CR 9 (Beekman Rd) Safety Assessment

CR 29 (Carpenter/Clove Branch Rd)-Taconic State Parkway, Town of East Fishkill

January 2019

Dutchess County Transportation Council

**Fig. 5. CR 9 (Beekman Rd) Safety Assessment
CR 29 (Carpenter/Clove Branch Rd) - TSP
Town of East Fishkill**

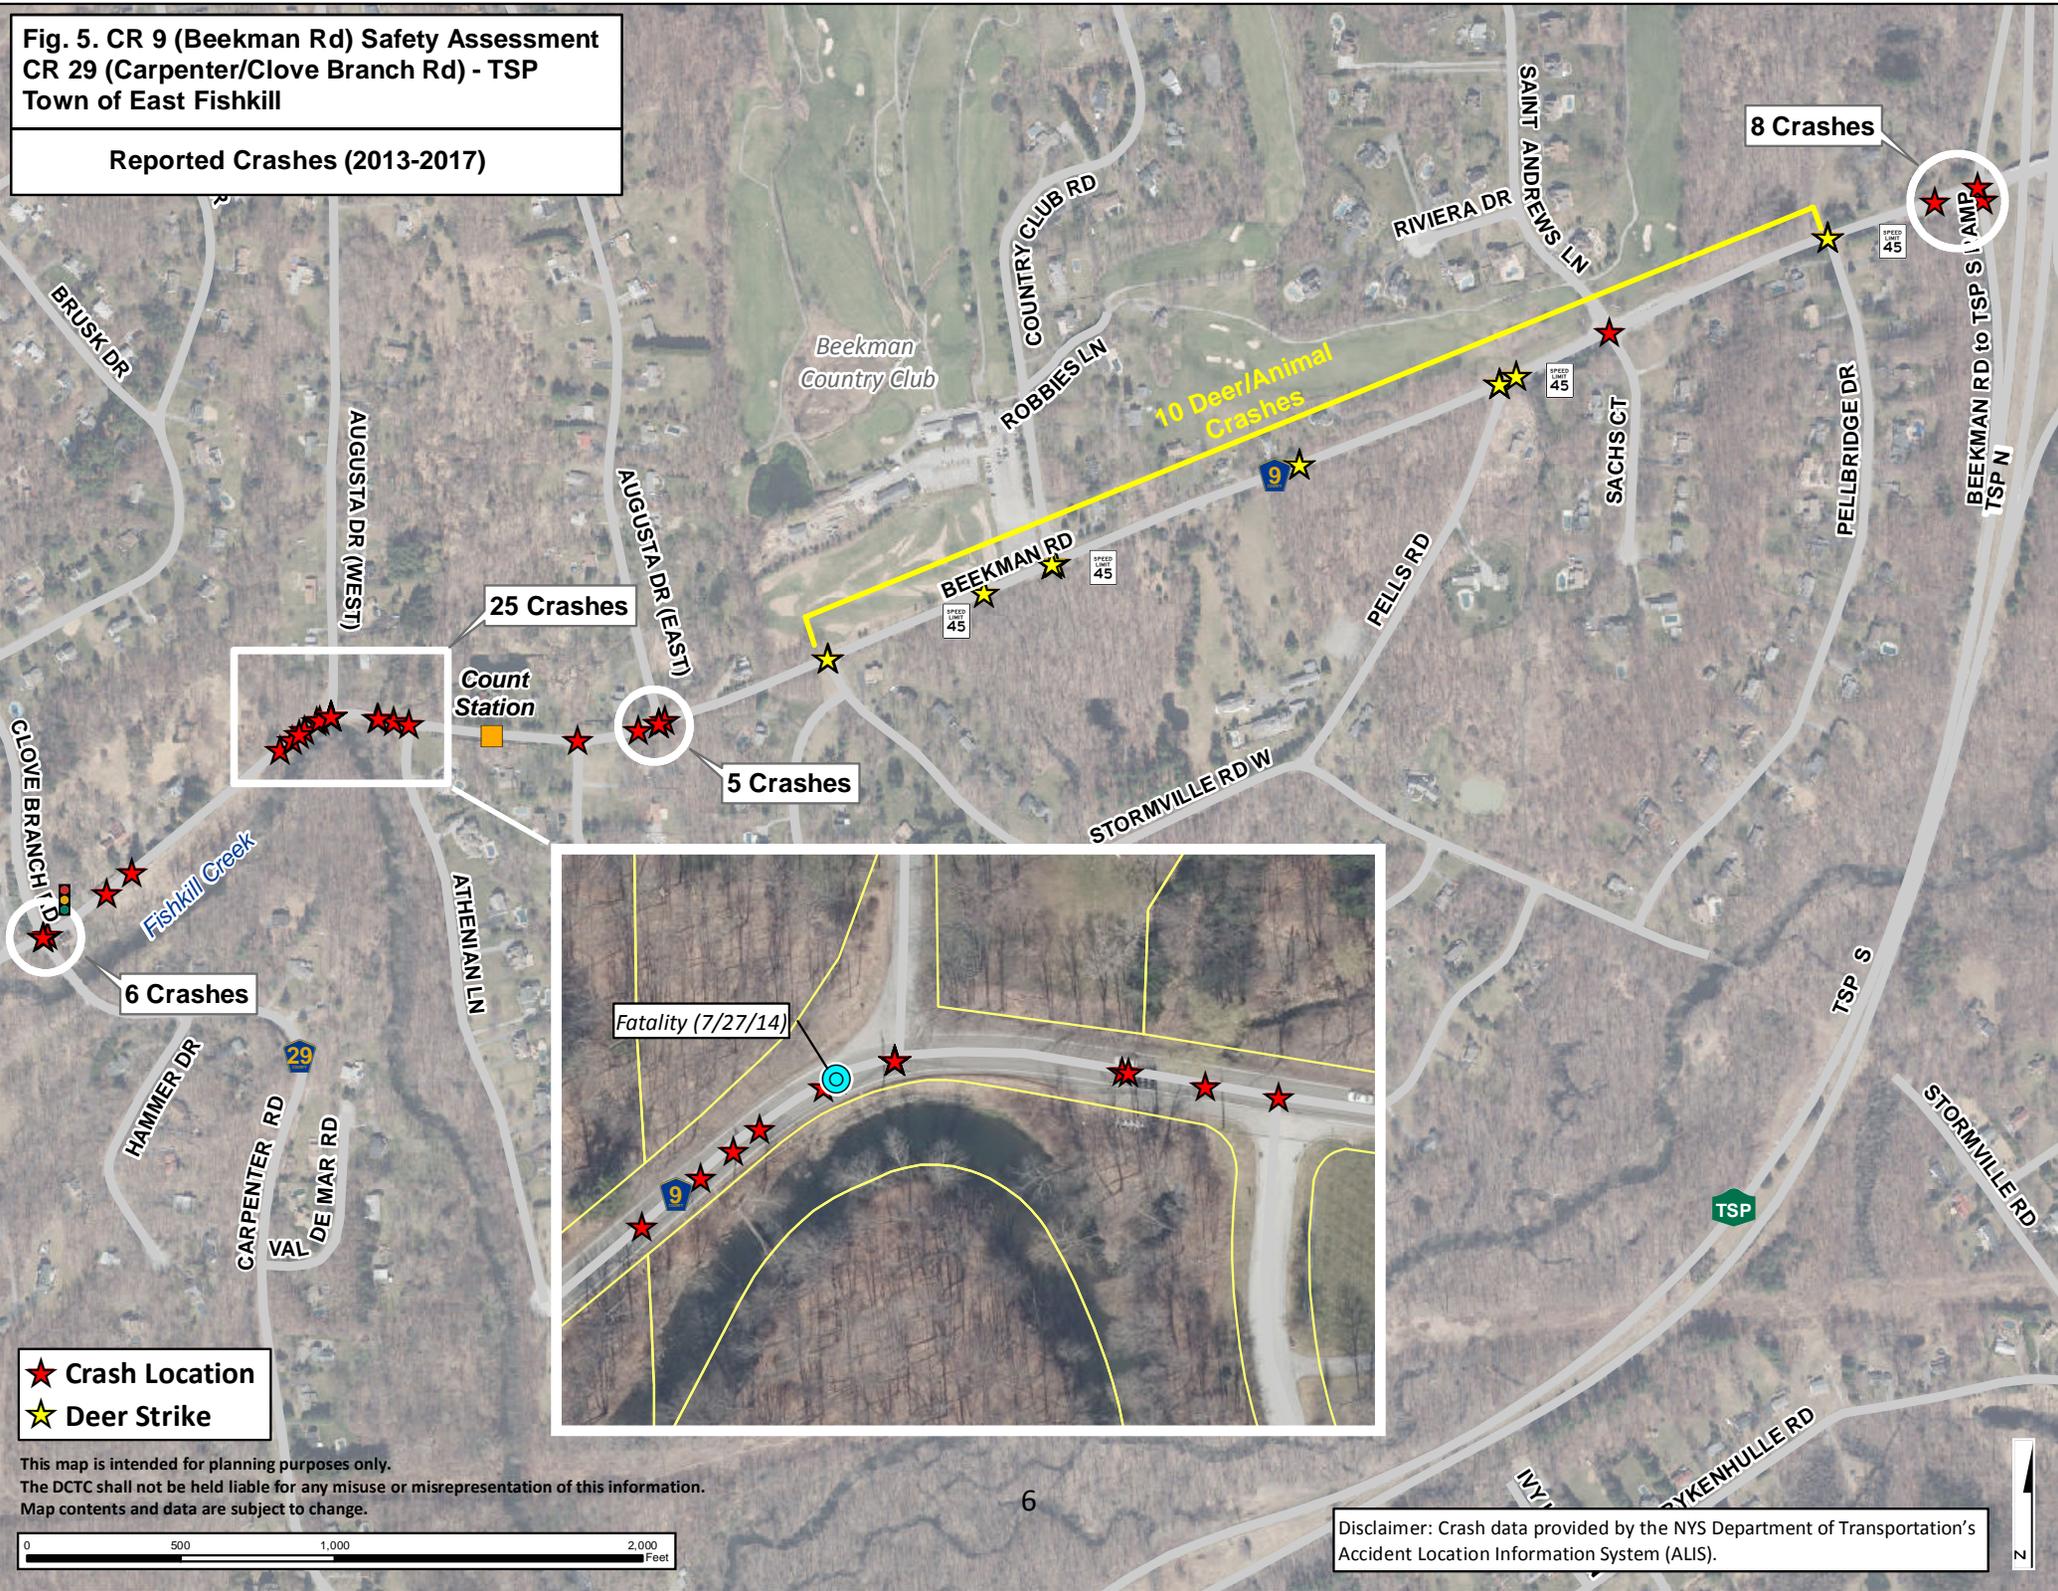
This 1.3-mile stretch of Beekman Rd experienced 71 crashes from 2013-2017, which resulted in one fatality (July 27, 2014) and 45 reported injuries. The crash analysis indicated that the majority of crashes (63 percent) occurred during daytime conditions, and wet or snowy road surface conditions were present during 48 percent of the crashes. Of the 71 crashes, 25 (or 35 percent) occurred in and around the Augusta Dr (West) and Athenian Ln intersections, with many of these located on the northern edge of the curve just west of Augusta Dr (West). During the five-year period, the number of crashes on the study corridor remained relatively constant, averaging 14 crashes annually. The analysis also revealed that ten of the crashes (14 percent) were deer or animal related, which is average for Dutchess County as a whole. Lastly, about half of the crashes involved multiple vehicles, suggesting possible issues related to the intersections and turning movements. Table 2 summarizes crash data for the study corridor, and Fig. 5 shows the locations of crashes on the study corridor.

Fig. 18. This area west of the curve near Augusta Dr (West) has witnessed numerous road departure crashes, as evidenced by the vehicle debris field and tree damage.

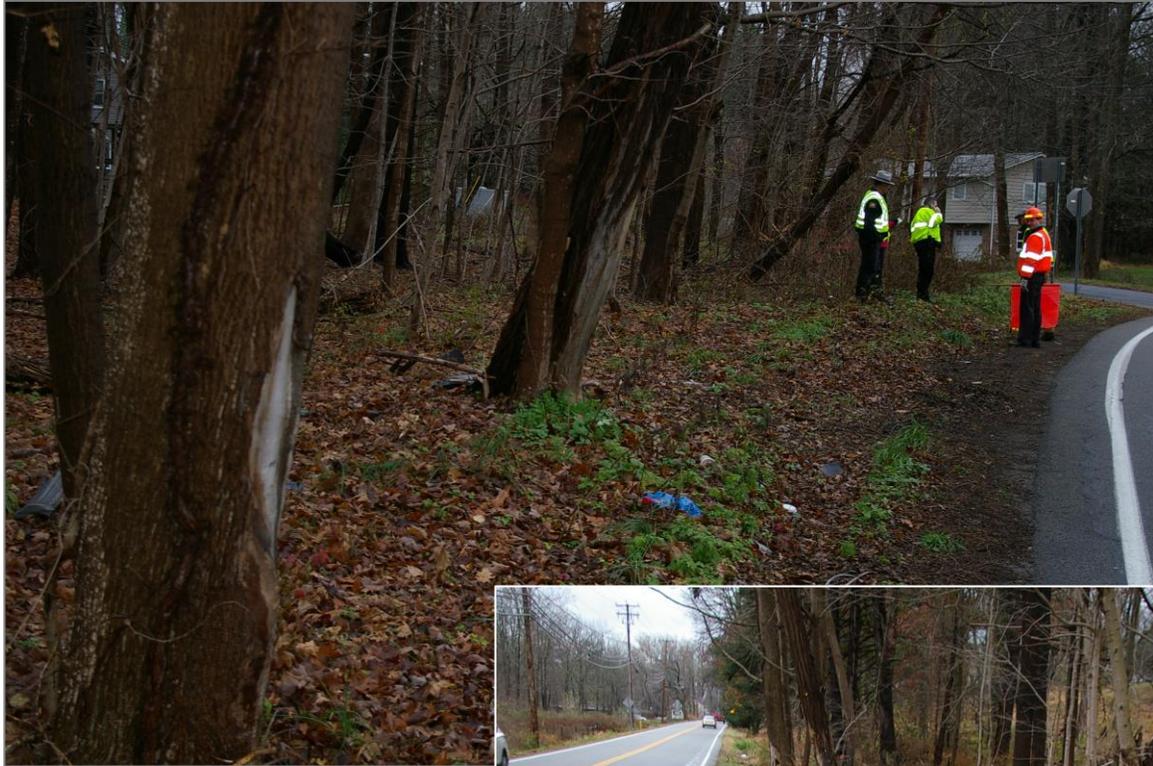
Observations: Crash data indicated that wet or snowy road conditions were present at 19 of the 25 crashes at this location (76 percent). Evidence of previous crashes was present during the site visit, especially at the apex of the curve, where a number of trees showed signs of repeated vehicle impacts. The area also appeared to have poor drainage that could diminish the capacity of drivers to recover from a road departure. Once off the pavement, there is a high probability of a collision with a fixed object such as a tree. The SA team noted that westbound vehicles tended to gain speed as they approached the curve, partly due to the elevation of Beekman Rd. The SA team also observed that the crash area off of Beekman Rd was moderately wooded and potentially unforgiving to errant vehicles (several vehicle parts were visible in the area, including a tire). The SA team also wondered if the super-elevation of the road might contribute to vehicles departing the road at the curve. See Fig. 18 and 19.

Risk Analysis: The combination of a tight horizontal curvature, narrow shoulders, and relatively high approach speeds create a challenging environment for drivers. The potential for a roadway departure increases when the pavement is slippery, as evidenced by the crash data. In addition, the presence of large trees just off the road, near the apex of the curve, increases the likelihood of a fixed object crash, while narrow shoulders and steep drop-offs impact recovery abilities.

1. As part of normal tree maintenance, DCDPW should ensure that the County right-of-way is free and clear of obstructions and that the clear zone is sufficient for this type of facility. If vegetation is located on private property and is determined to compromise safety, DCDPW should notify the applicable property owner of the situation and suggest that they remove the obstructions.
2. The suggestion above should be done in conjunction with installing a defined clear zone at the apex of the curve on the northern edge of Beekman Rd. A clear zone is an unobstructed, traversable area beyond the edge of the travel lane that enables errant vehicles to recover from a road departure, and if unable to recover, reduces the effects

of the road departure. Clear zones are free of rigid fixed objects such as trees and utility poles. For this location, this would entail removing a majority of trees located within the County right-of-way on the northern edge of Beekman Rd, just west of Augusta Dr (West). The amount of clear zone created should follow AASHTO's Roadside Design Guide and account for the road's design speed and the radius of the curve.

3. Consider installing Slippery When Wet signs (W8-5) to warn drivers approaching the curve. This would respond to the number of incidents occurring under wet pavement conditions. While the SA Team agreed that these signs are applicable, the group also felt adding more signs at or before the curves could detract from the primary message about the geometry. If installed, the placement of these signs should be carefully considered as part of the overall signage package for Beekman Rd.

4. Consider a high-friction pavement overlay or other treatment to improve skid resistance. The installation of a higher friction pavement treatment through the curve would increase the horizontal friction factor, especially during periods of rain, and help keep vehicles from departing the road. The SA team discussed alternative treatments including a rough asphalt top course and micro-surfacing. Further study and evaluation would be required to determine which would be the best treatment for Beekman Rd.

5. Assess the super-elevation of the road to ensure it meets current design standards.
